## ZONING COMMITTEE STAFF REPORT

FILE # 18-117-556

1. **APPLICANT:** Rehder And Associates on behalf of Twin Cities German Immersion School
  2. **TYPE OF APPLICATION:** Site Plan Review **HEARING DATE:** 12/20/2018

3. **LOCATION:** 1031 Como Ave (between Argyle and Churchill)
  4. **PIN & LEGAL DESCRIPTION:** 262923220173 Warrendale Subj To Esmt, Vac Alley Accruing And Fol, Beg At The Nw Cor Of Lot 19 Thence Sely On The Nely Lot Line 60 Ft Thence S 78 Ft To Pt 48.5 Ft E At Ra From W Line Of Sd Lot Thence Swly 41.4 Ft To Pt On S Line 25 Ft E At Ra From W Line Thence Wly On SD LINE 28 FT TO SW COR THENCE N 130.7 FT TO POB BEING PT OF LOT 19 ALSO ALL OF LOTS 10 THRU LOT 15 & LOTS 20 THRU LOT 23 BLK 4

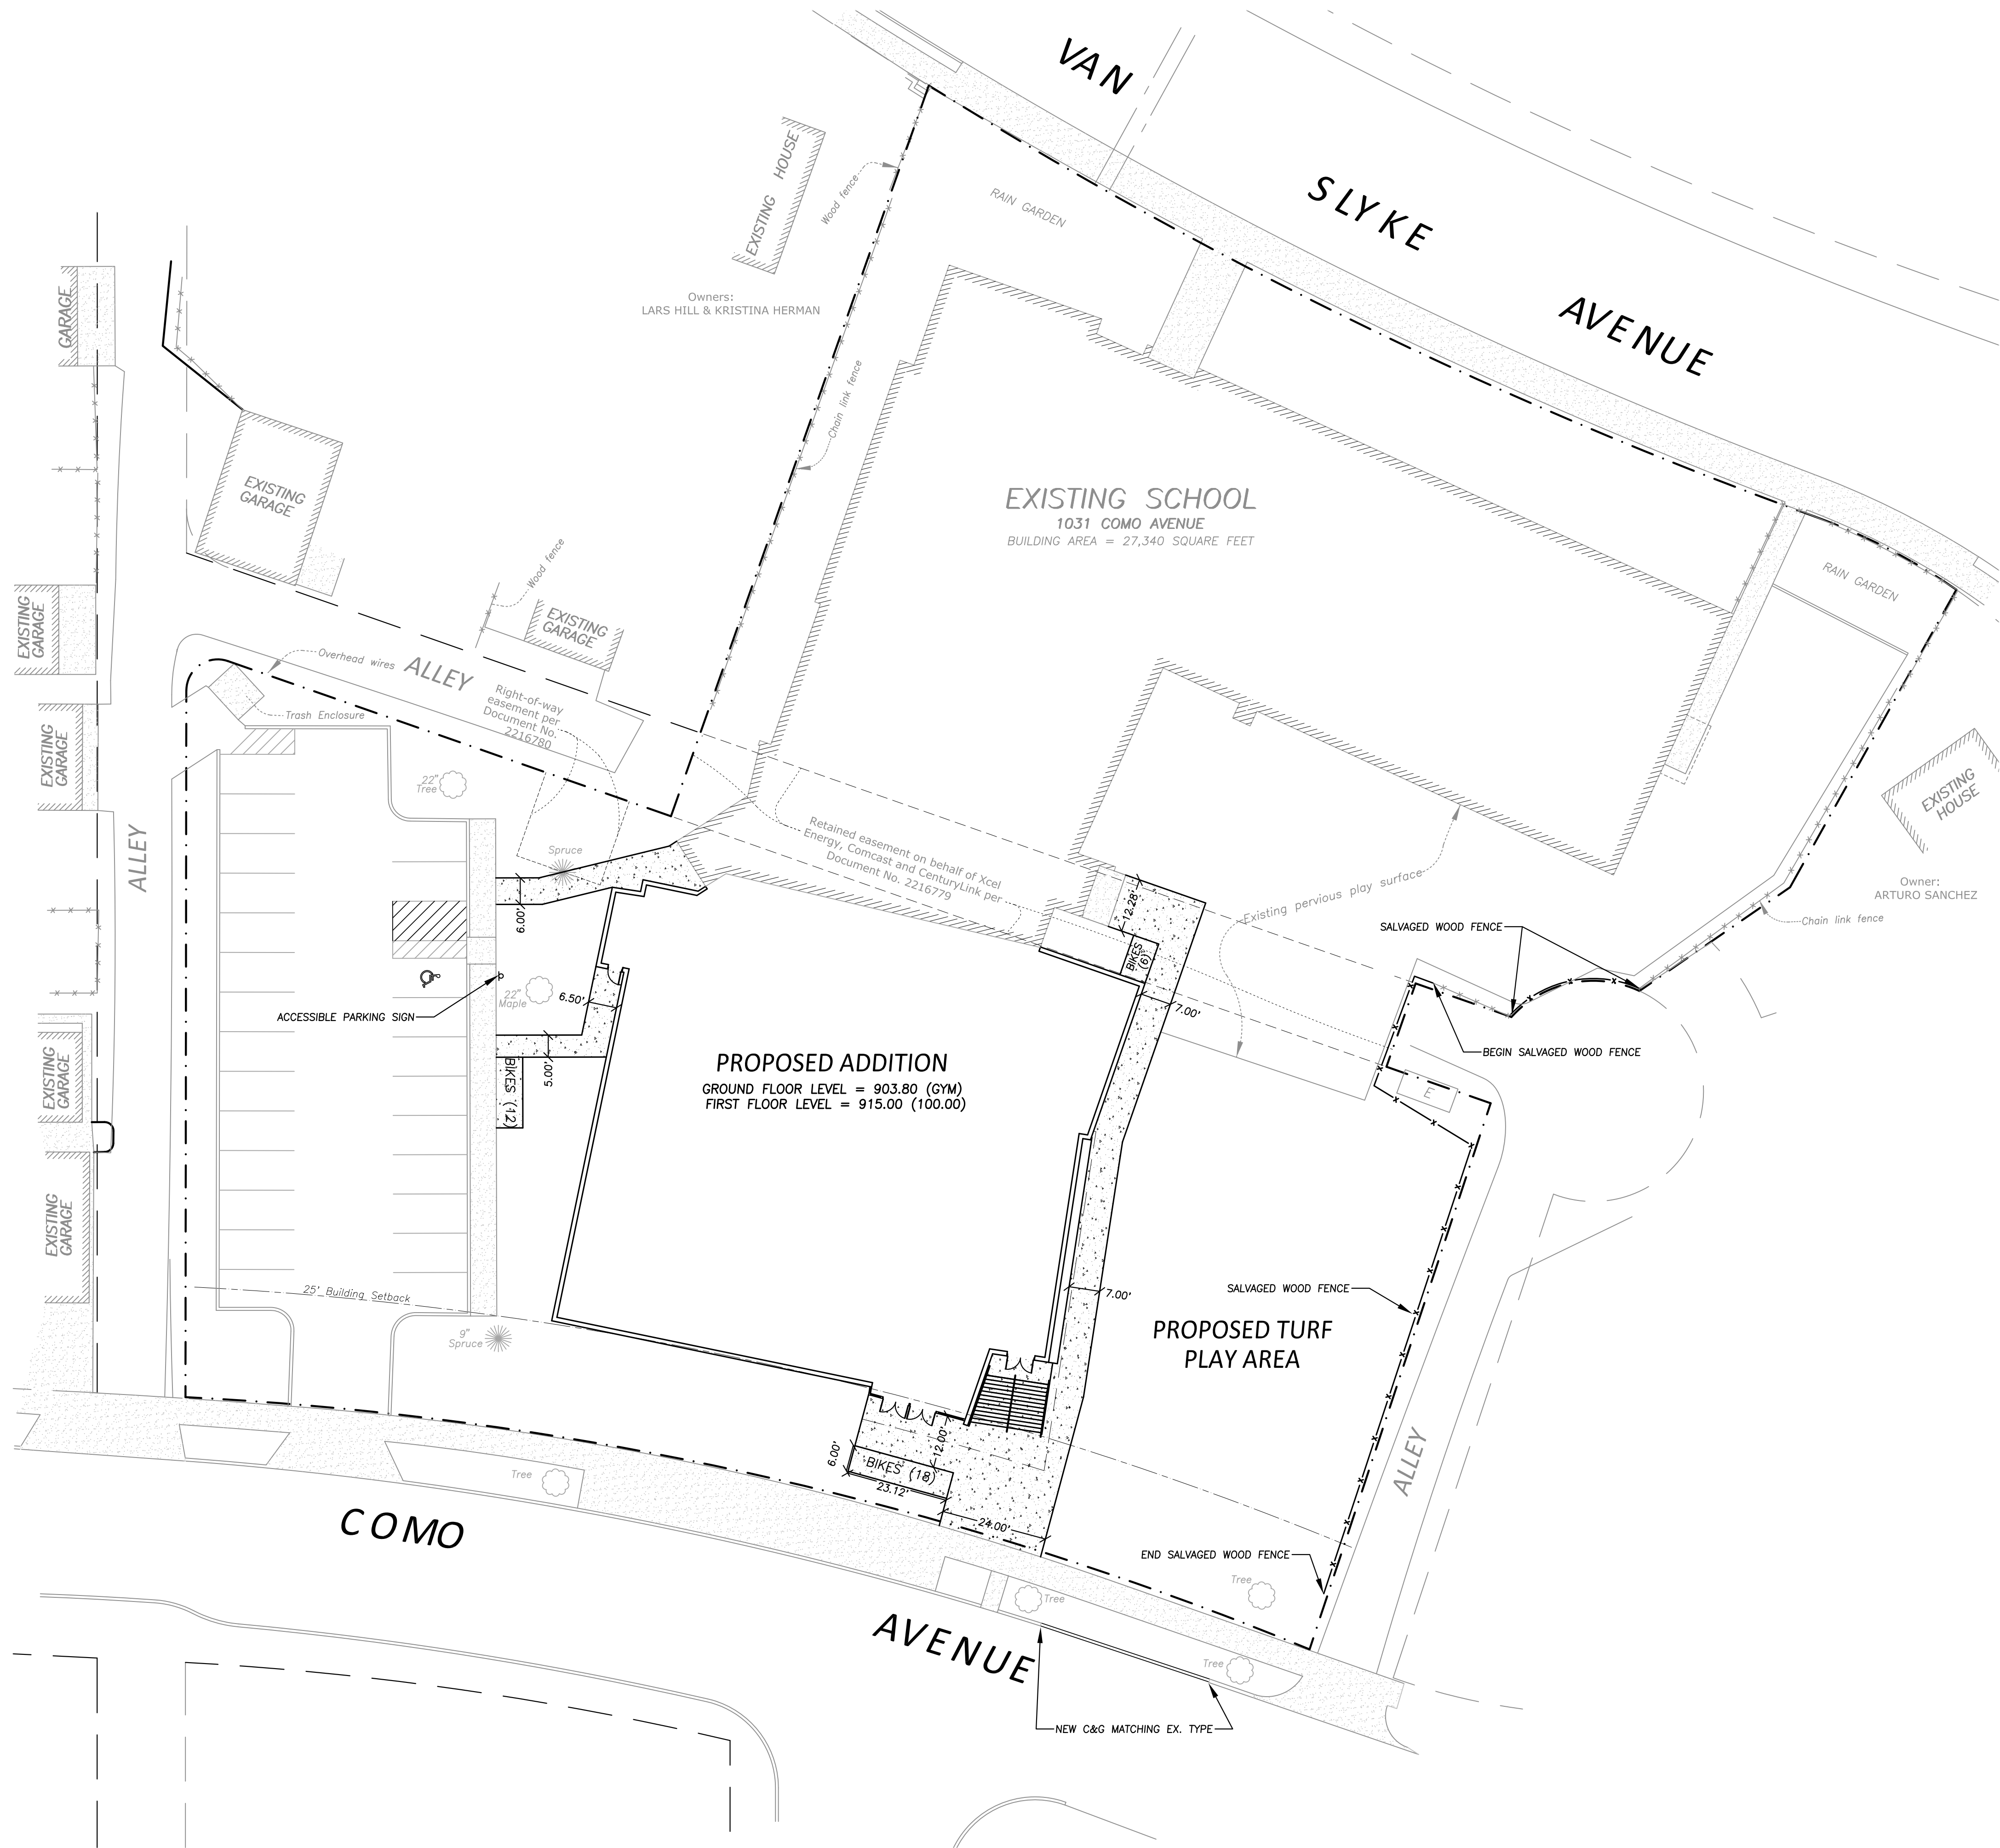
- d) Please remove any encroachments of private property onto public rights-of-way and update the Removal Plan Sheet C0 accordingly. The Survey plan sheet shows a fence encroaching into the alley east of the property.

- f) On Plan Sheet C0, please show removal of the outwalk adjacent to the driveway proposed for removal.
- g) Please provide a traffic impact study of the existing conditions and proposed improvements. Please contact David Kuebler at 651.266.6217 with questions regarding the study.

- b) Sheet C0: Demo Plan
  - Tree protection fencing is required around the existing street trees on Como Avenue. Show this on the plan sheet and include a tree protection fence detail in the plan set.  
A tree protection detail 7/C3 was added. Silt fence is also shown around the three trees on sheet C0 near Como Avenue.

- Along with demolition note one, all base materials under pavements in the boulevard area are to be removed.  
This note was added to sheet C0.
- c) Sheet L1: Landscape Plan
